**SUBJECT:** **Safety Recall 20S31 – Supplement #1**  
 Certain 2014-2017 Model Year F-150 Vehicles Equipped with 3.5L Ecoboost Engines  
 Brake Master Cylinder Replacement

**REF:** **Safety Recall 20S31**  
 Dated: October 6, 2020

**New! REASON FOR THIS SUPPLEMENT**

FIGURE 1

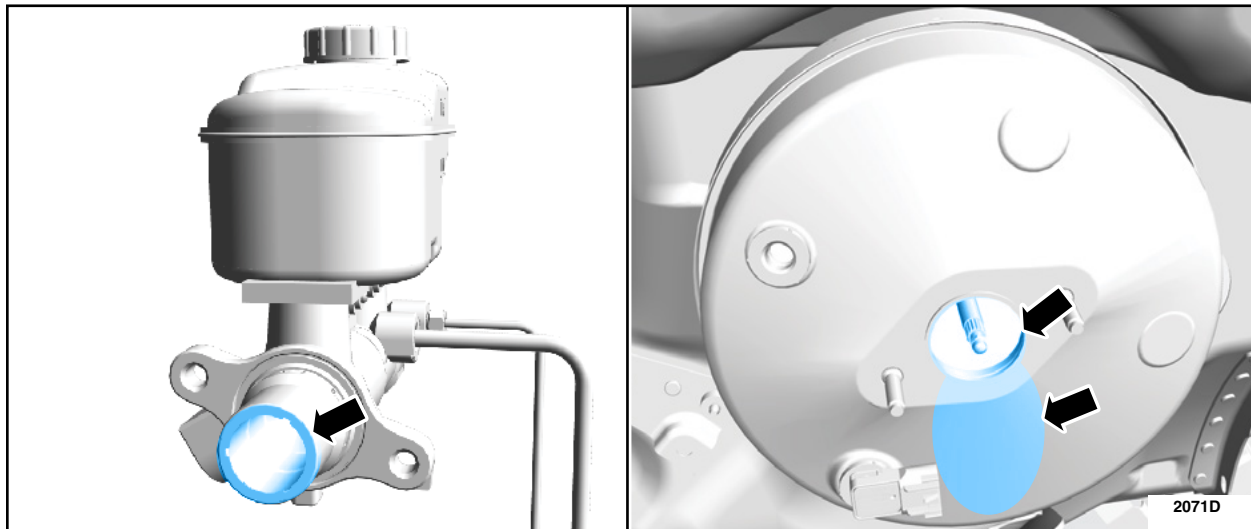
1. Position the vehicle on a hoist. Please follow the Workshop Manual (WSM) procedures in Section 100-02.
2. Remove the master cylinder. Please follow the WSM procedures in Section 206-06.
3. Inspect the rear of the master cylinder and the mounting surface of the brake booster.  
Are there signs of leaking brake fluid? Signs of leaking brake fluid may include fluid on the back of the master cylinder or on the mounting surface of the brake booster, and/or peeling paint on the brake booster. See Figure 1.

Yes - Replace the brake booster. Please follow the WSM procedures in Section 206-07, then proceed to Step 4.

No - Proceed to Step 4.
